Technical Service Information

THM 440-T4 DELAYED 2-3 SHIFT

Figure 1

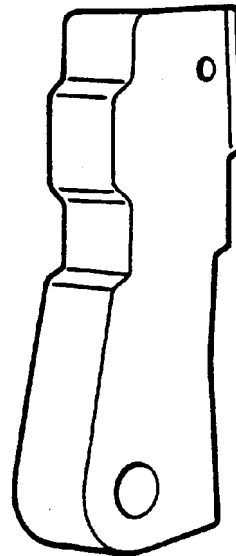
A long and/or delayed 2-3 shift on THM 440-T4 transaxle may be caused by a leaking 3rd clutch inner seal (Figure 1, Item 635A). A new, thicker seal is used in production and available for service replacement. The new seal can be recognized by a small group of hash marks on the inside diameter of the seal.

**INSPECT FOR
DENT OR ROUGH
METAL FINISH
IN THIS AREA**
